SUBDIVISION REVIEW SHEET

CASE NO.: C8-2018-0165.4A

SUBDIVISION NAME: Cascades at Onion Creek East, Phase Four

CITY OF AUSTIN –DEVELOPMENT SERVICES DEPARTMENT
SUBDIVISION APPLICATION – MASTER COMMENT REPORT

CASCADES AT ONION CREEK EAST, PHASE FOUR

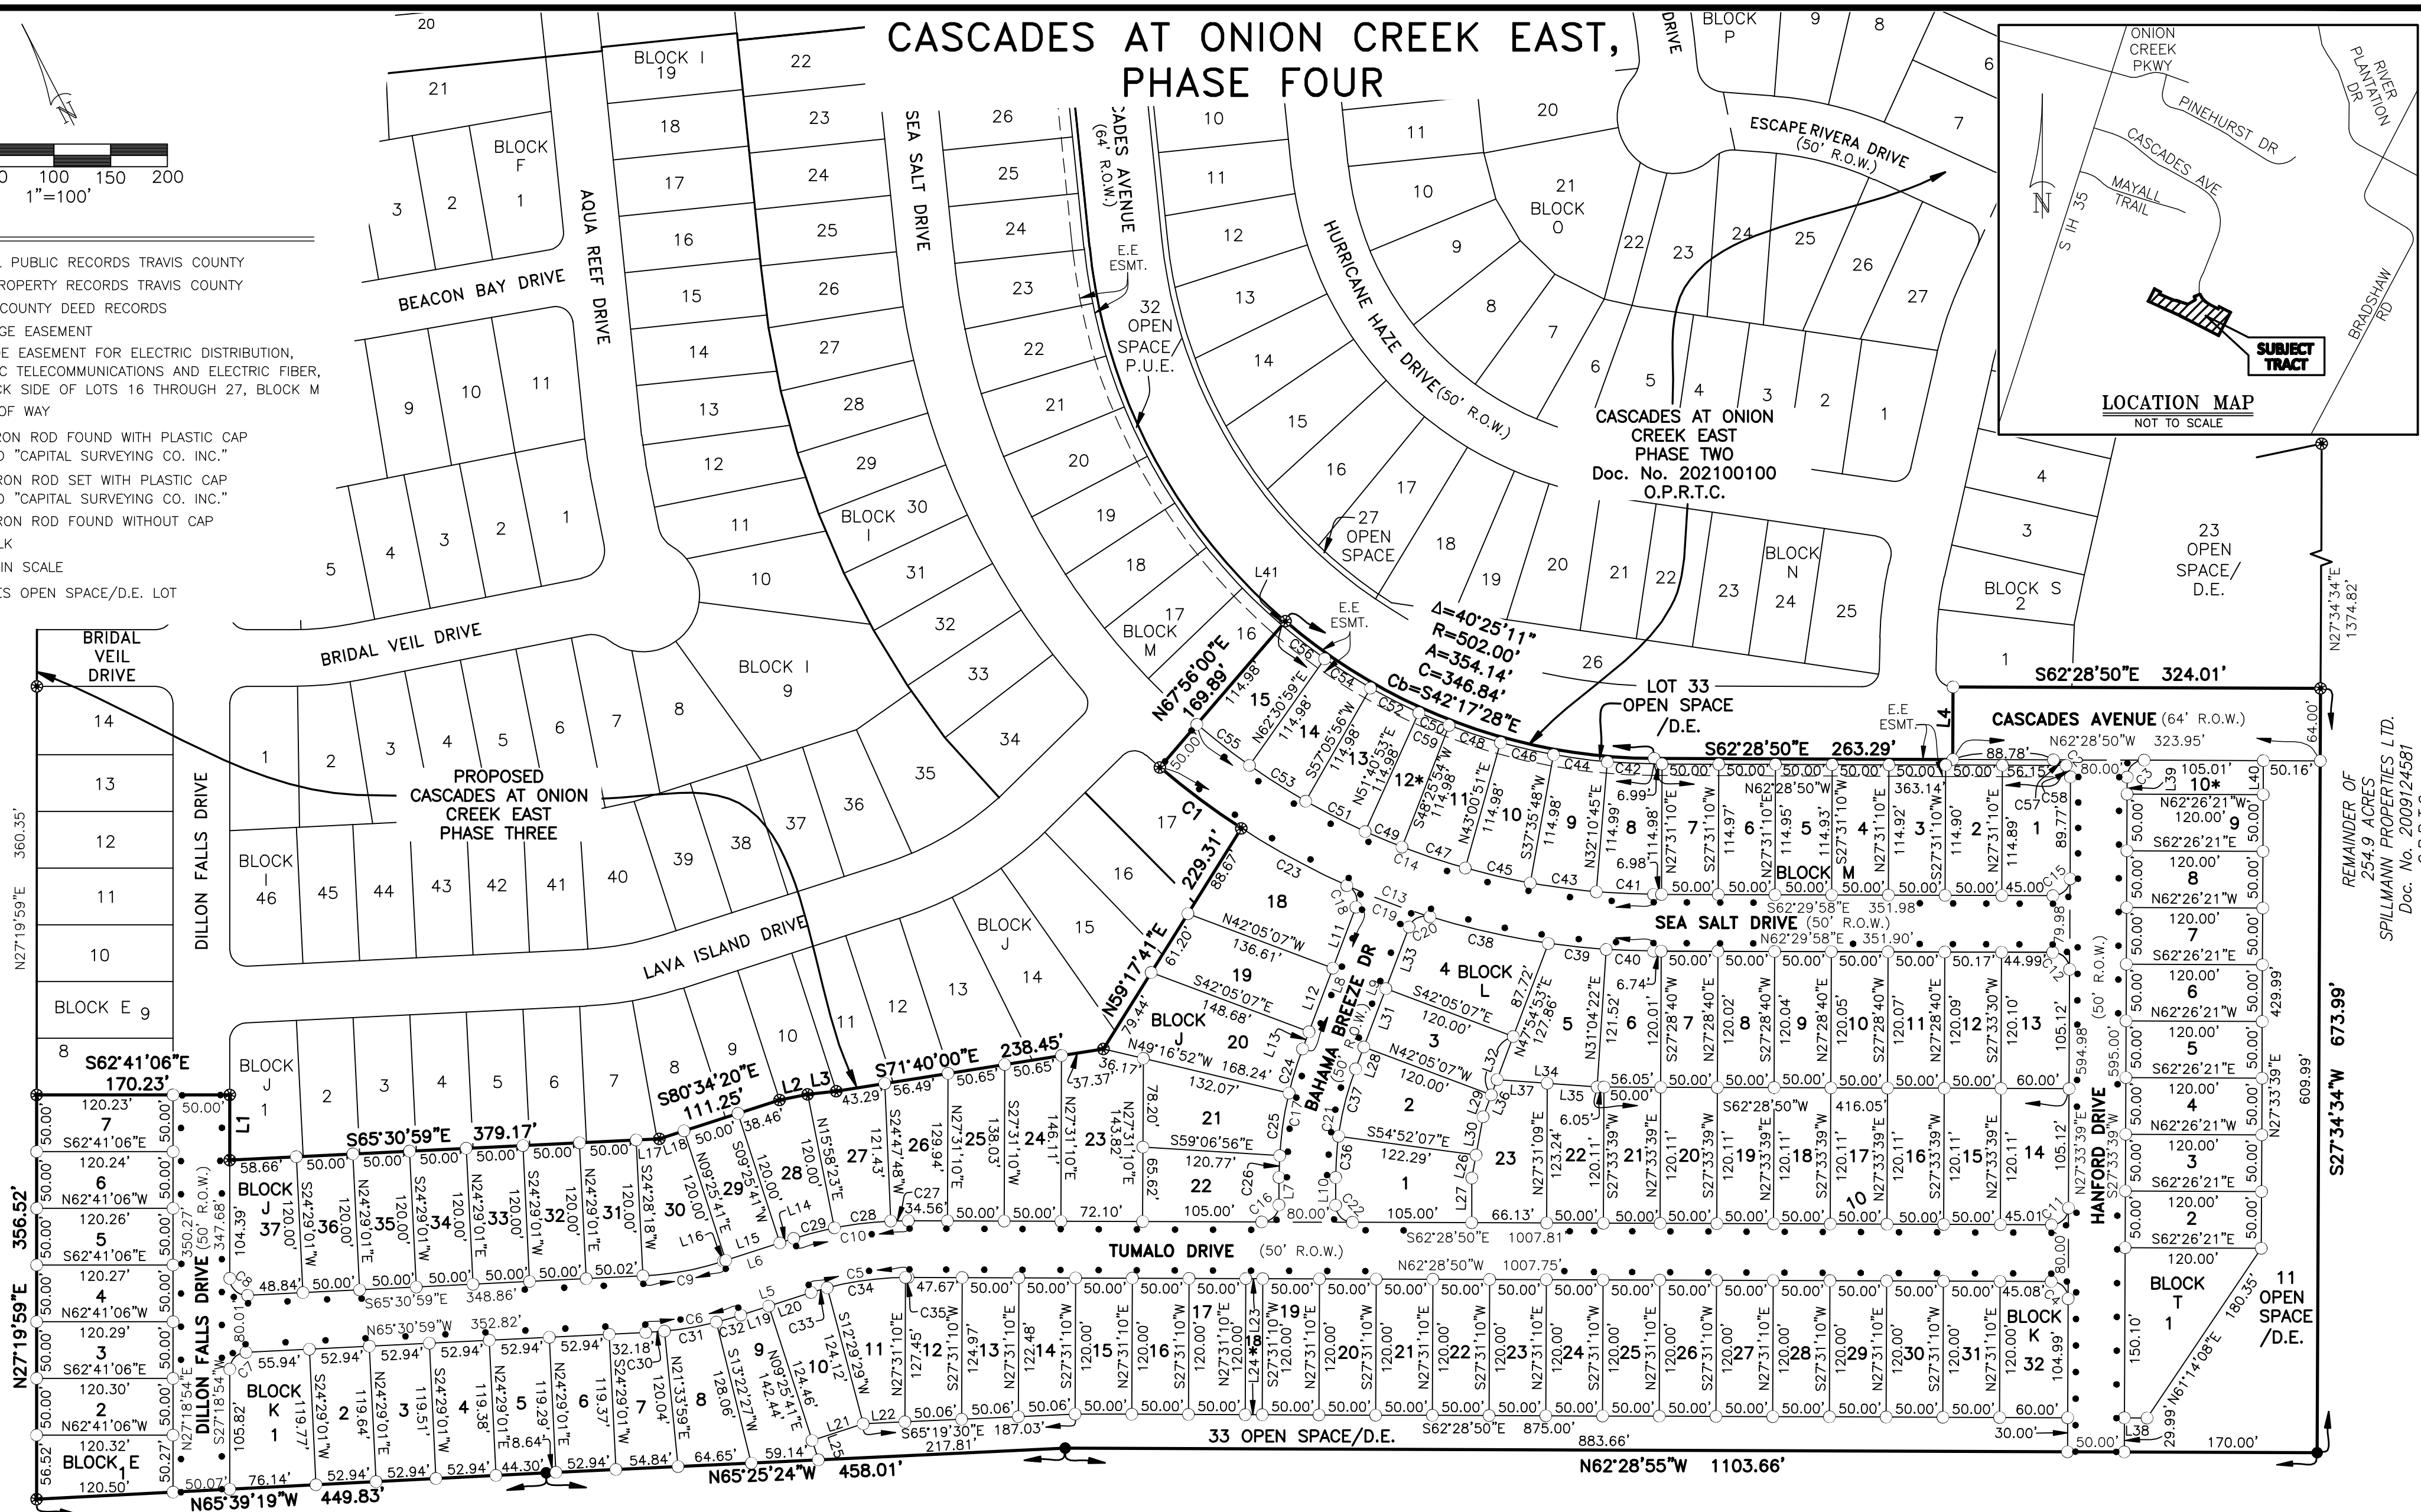
AD2: HANFORD DR - Duplicate with active street name

DE 1. There is a significant off-site drainage area draining to this subdivision's southeast corner, (DA 300, 64.9 acres). Provide additional hydrologic/hydraulic analysis demonstrating that the off-site drainage can be conveyed through the subdivision and the 100 yr fully developed runoff will be contained within the drainage easements [LDC 25-7-151 and 152]

Update #1: Response indicates that a channel is proposed to convey the runoff around the lots to be located in the Open Space/DE lot. Plans show grass lined and concrete lined channels without a street extension. Provide plan and profile with associated calculations demonstrating that the 100 year WSEL will be contained in the drainage easement.

DE 6. Access from a public road is required for maintenance and/or inspection of all Drainage Easements 25 feet or larger - label all proposed Drainage Easements and provide a Drainage Access Easement of no less than 15 feet in width. [LDC 25-7-152]

Update #1: Response indicates access is provided but additional access may be needed for maintenance of the channel proposed on Lot 33.
